HDC

ADMINISTRATIVE APPROVALS

September 02, 2026

PROPOSED ALUMINUM FENCE

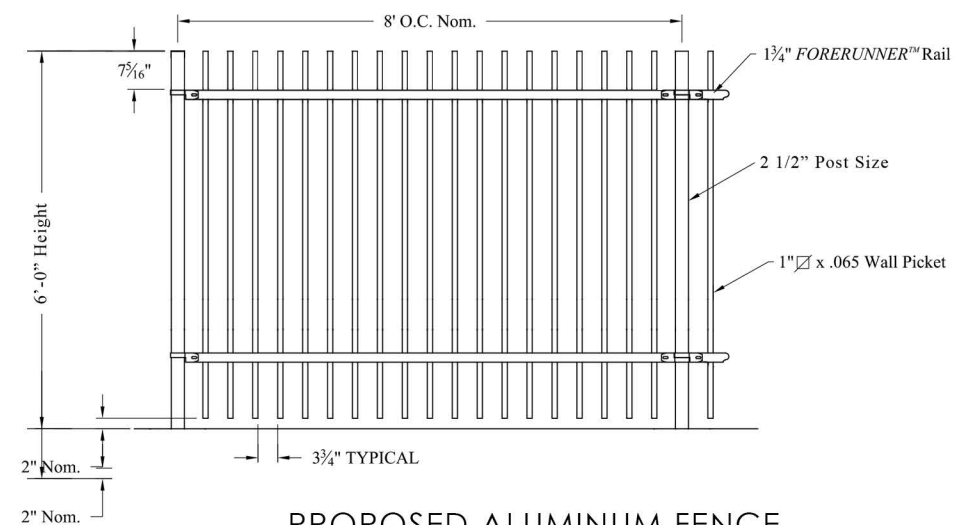
2A
The six foot high aluminum picket fence that was approved for AREA 2A has been installed per approval. the picket style has been revised to be square.

PROPOSED ALUMINUM FENCE:
MANUFACTURER: AMERISTAR FENCE
STYLE: ECHELON II CLASSIC
COLOR: BLACK
DIMENSIONS: 8'-0" WIDTH x 6'-0" HEIGHT

APPROVED ELEVATION OF NEW GATE AT DRIVEWAY

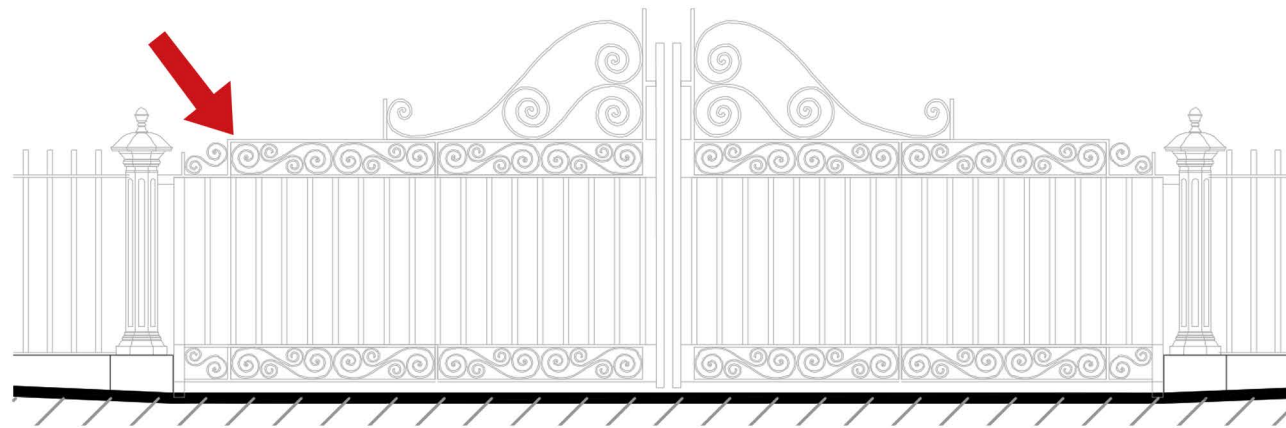
In **AREA 4**, there has been a modification proposed by New England Castings, LLC and Knight Welding to revise the top section of the larger gate structure.

3B. EGRESS WINDOWS AND GARAGE DOOR

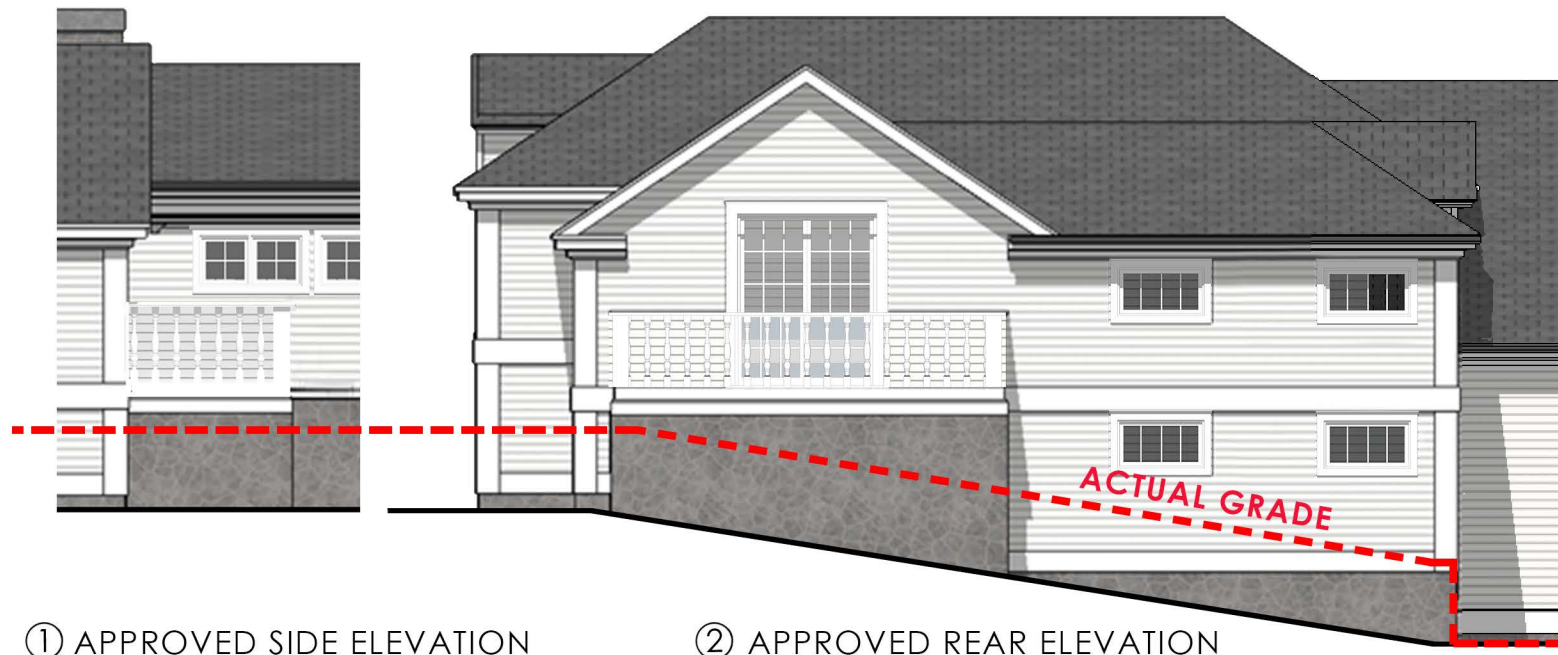
The approved double hung windows in the rear dormer are proposed to be casement with a faux check rail in order to meet code requirements.

4. CARRIAGE HOUSE TRIM

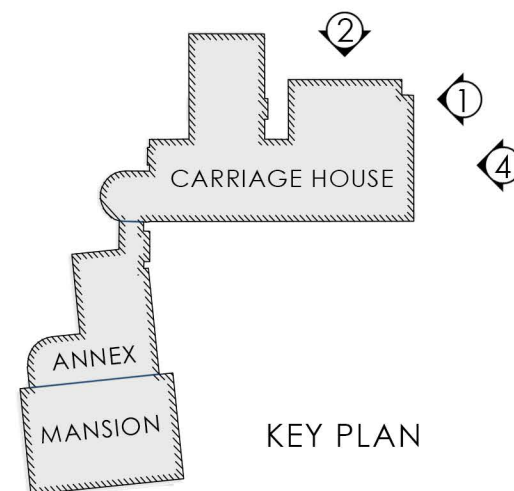
The grade around the back and side of the carriage house was significantly higher than anticipated, therefore the horizontal band was removed, and the water table remains installed at a higher level.

The patio railing was updated to 42" high rail per code and as a result, metal pickets are preferred.

6. RESTORED WINDOW RELOCATED TO SUPPORT EGRESS REQUIREMENTS

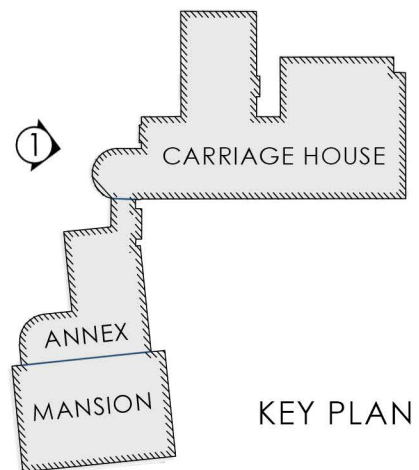
Windows approved for restoration in the annex have been restored and reinstalled. The approved location has been revised due to egress window requirements. The restored window has been used to infill a door opening on the north side that had been previously demolished.

① AS-BUILT APPROVED SQUARE NOSING GRANITE STEPS

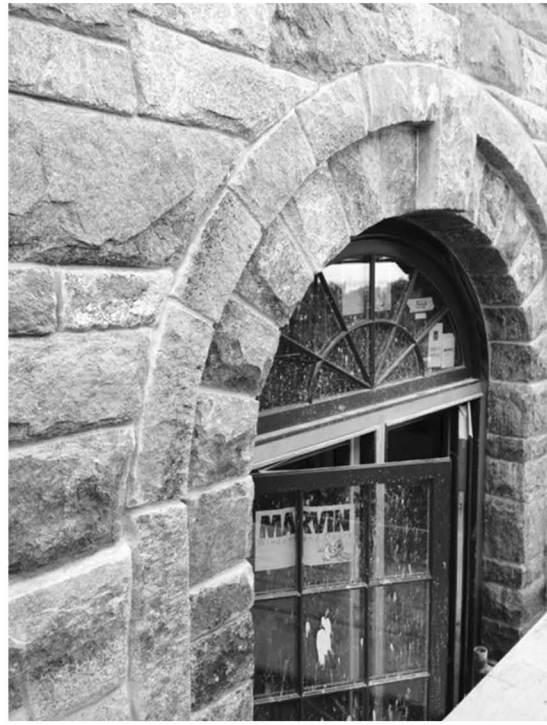
Clarification: Two types of stair tread images were submitted and approved. One depicts a square nosing and the other shows a radius nosing. The owner prefers the square edge nosing.

8. CARRAIGE HOUSE – REAR STONE ELEVATION

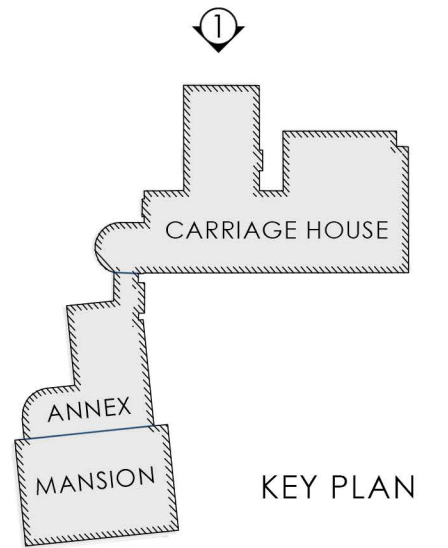
The rear elevation of the Carraige House stone and approved arch details have been developed around the door opening.

The Stone Masons Inc. expressed an interest in further developing the wall to include planter expressions using the same approved arch detail to flank their work around the door.

AS-BUILT HILLSIDE RETAINING WALL AT AREA 5

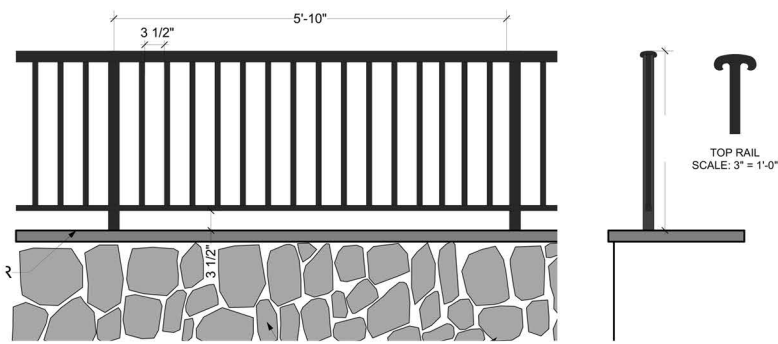
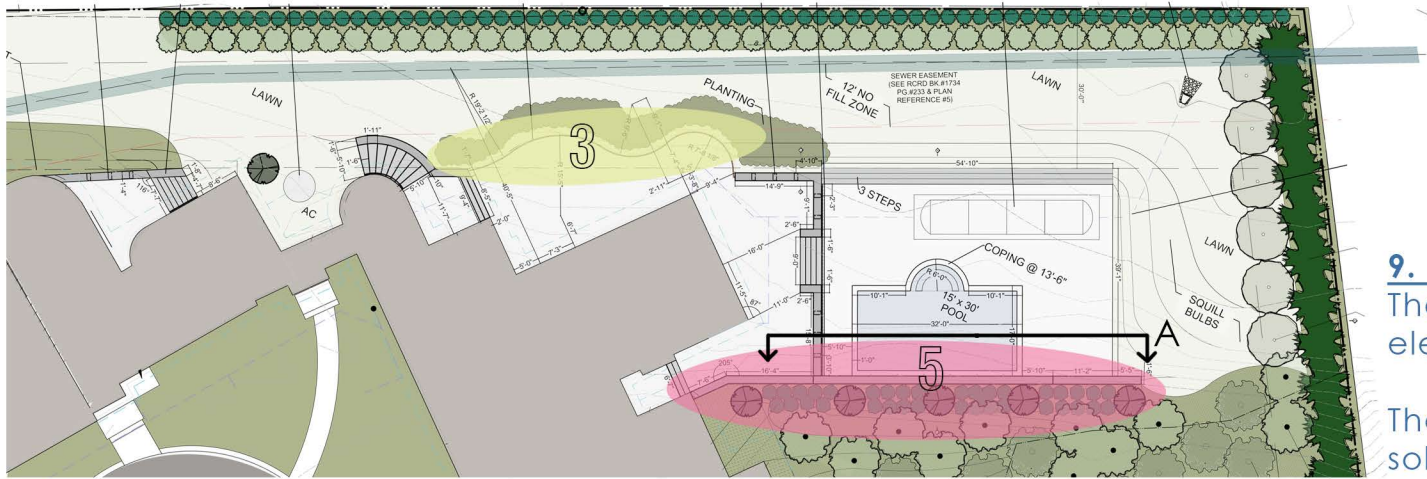
The Retaining wall at the hillside was revised to support existing grade conditions as well as a solid ledge outcropping located on the uphill side of the wall.

4.Proposed Window

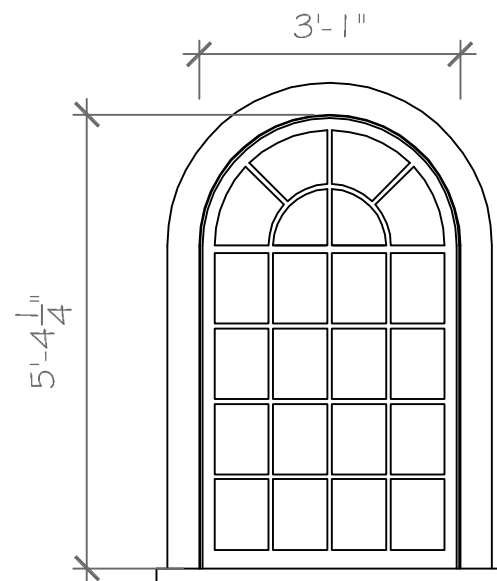
TO NOTE:
THE EXISTING WINDOW DEMONSTRATES
EVIDENCE OF MODIFICATIONS AND
ALUMINUM COMPONENTS.
AS EXISTS, IT IS NOT AN ORIGINAL
FEATURE OF THE 1750 STRUCTURE.

- (1) PANE SHORTER TO ALLOW FOR PROPER FLASHING AT ROOF-WALL INTERSECTION
- OMIT DOUBLE HUNG SASH
- ALL REMAINING GLAZING PROPORTIONS TO REMAIN THE SAME
- ALL OTHER DETAILS AND DIMENSIONS TO MATCH EXISTING

Previously approved fence screening.

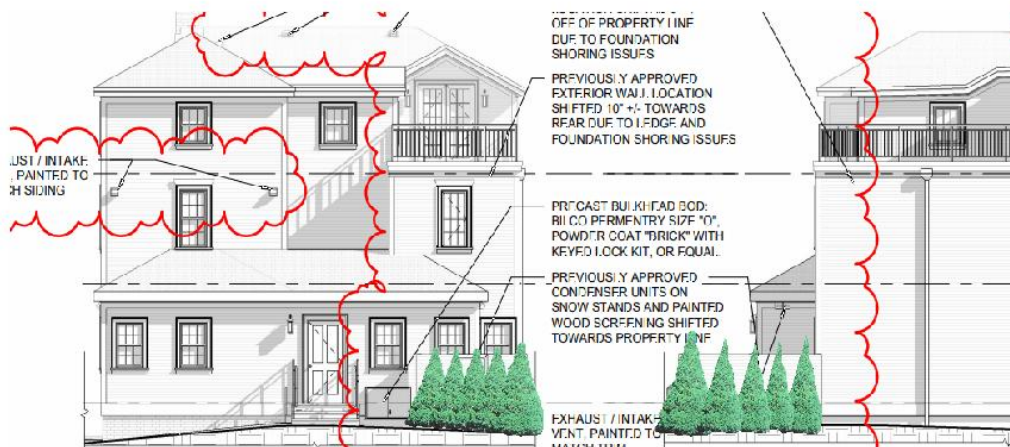
Background: The applicant is seeking approval for the omission of a previously approved fence and to replace it with a vegetative screening (this is to allow enough air to the condensers to meet code requirements).

Proposed vegetation.

1 GRANITE SILL DETAIL
1 1/2" = 1'-0"

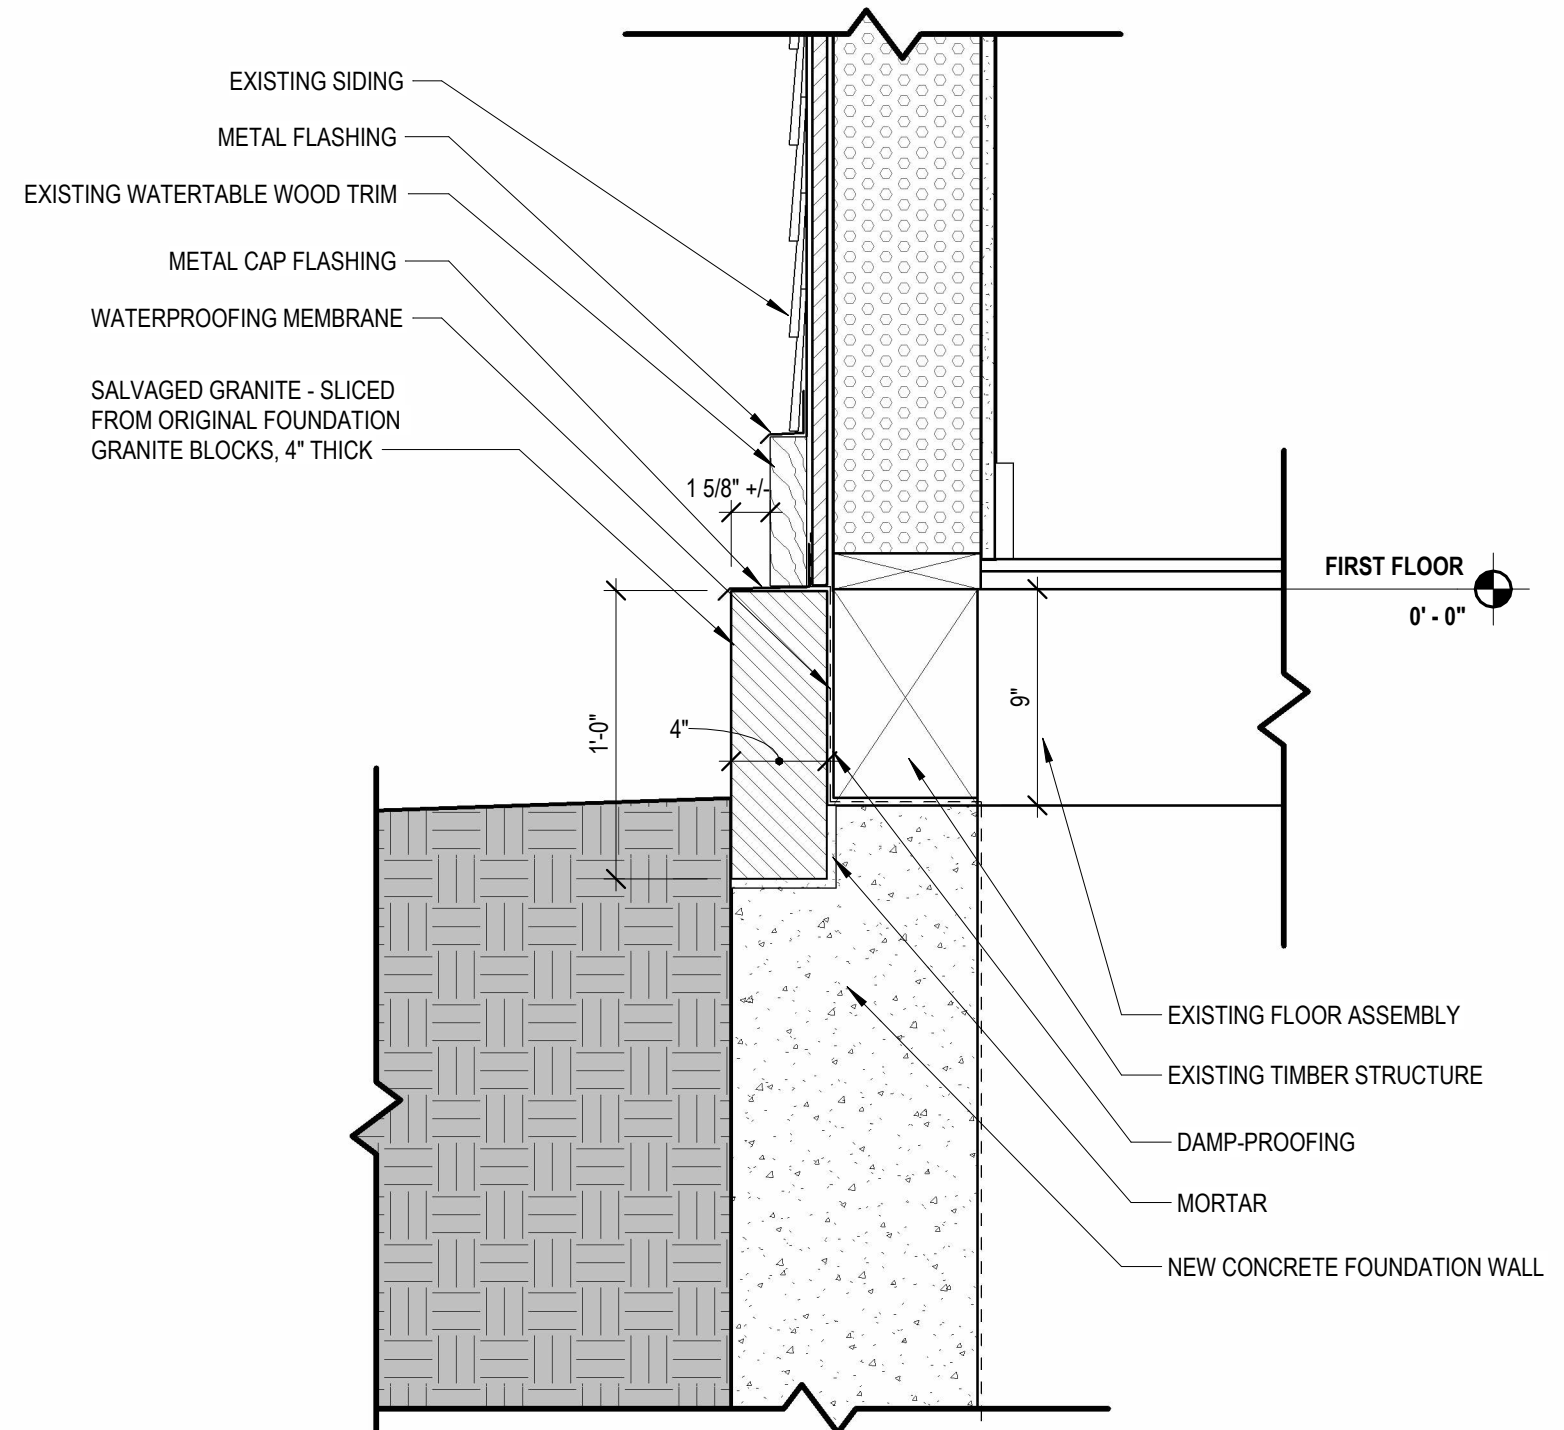
- GRANITE SILL REPLACEMENT:
AT FRONT NORTHEAST CORNER, REMOVE & REINSTALL TOP COURSE OF EXISTING GRANITE FOUNDATION, WITH THINNER PROFILE USING CUT EXISTING STONE. INSTALL NEW REINFORCED CONCRETE FOUNDATION WALL BEHIND THINNER GRANITE TOP COURSE AT FRONT PART OF BUILDING.

REMOVE GRANITE SILLS, CUT THINNER (4"), THEN REINSTALL IN SAME LOCATION ON NEW CONCRETE FOUNDATION SHELF.

② PROPOSED WEST ELEVATION
1/16" = 1'-0"

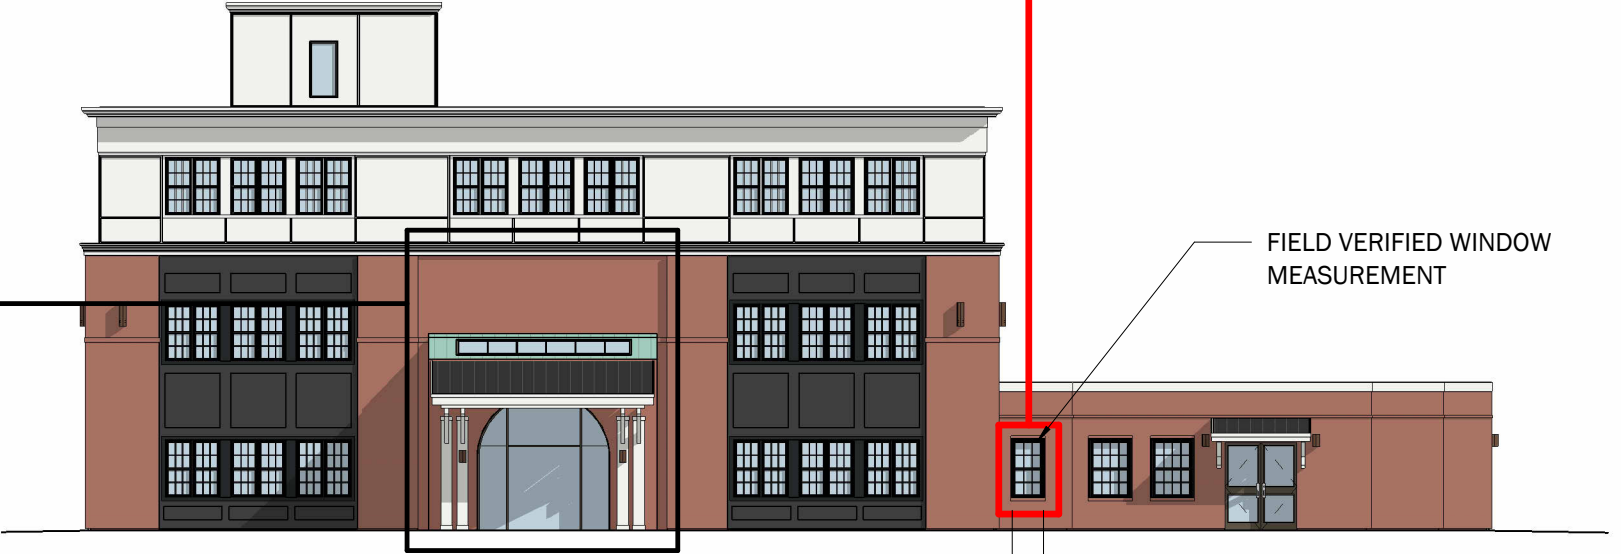
DUE TO THICKNESS OF PROPOSED THIN BRICK ASSEMBLY AND EXISTING SKYLIGHT, WE ARE PROPOSING TO REFINISH EXISTING STUCCO W/ STOCOLOR LASTIC FINISH. COLOR SIMILAR TO GLEN GERY THIN BRICK "SHENANDOAH"

- ③ PROPOSED SOUTH ELEVATION - OPTION 2
1/16" = 1'-0"
- SINGLE WIDE, 10/10 GRILLE PATTERN

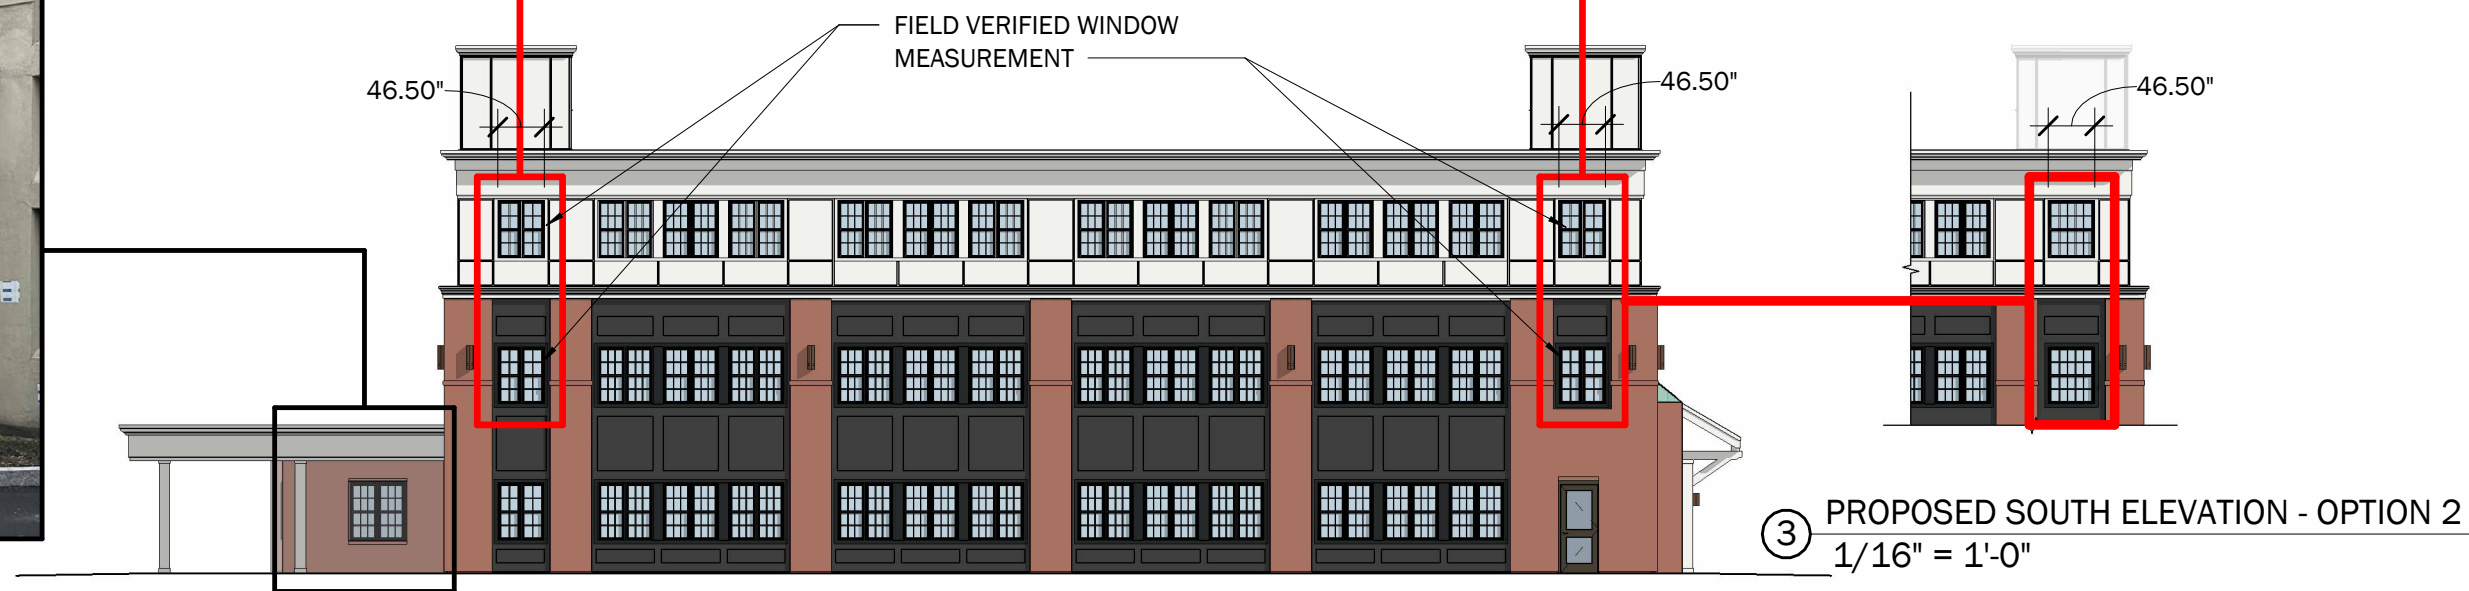
DUE TO THICKNESS OF PROPOSED THIN BRICK ASSEMBLY AND EXISTING WATER LINES, WE ARE PROPOSING TO REFINISH EXISTING STUCCO W/ STOCOLOR LASTIC FINISH. COLOR SIMILAR TO GLEN GERY THIN BRICK "SHENANDOAH"
